Certa-Lok®/IB & Certa-Lok® CLIC™ Compatiblity

Key differences between Certa-Lok/IB and Certa-Lok CLIC:

Figure 1. 4", 6", and 6.9" Certa-Lok/IB spigot end.

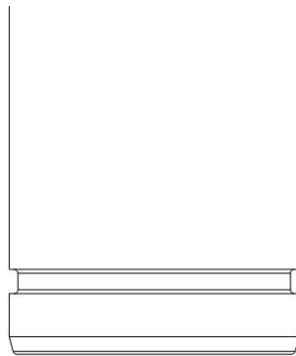
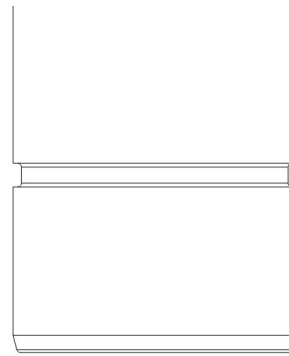
3. The 4", 6", and 6.9" nominal sizes of Certa-Lok/IB utilize a spline groove that is closer to the end of the pipe as shown below in figure 1. Because of this, in order to connect 4", 6", or 6.9" Certa-Lok CLIC casing to 4", 6", and 6.9" Certa-Lok/IB casing, you must use a Certa-Lok/IB to Certa-Lok CLIC adapter. The part numbers are included in the table below.
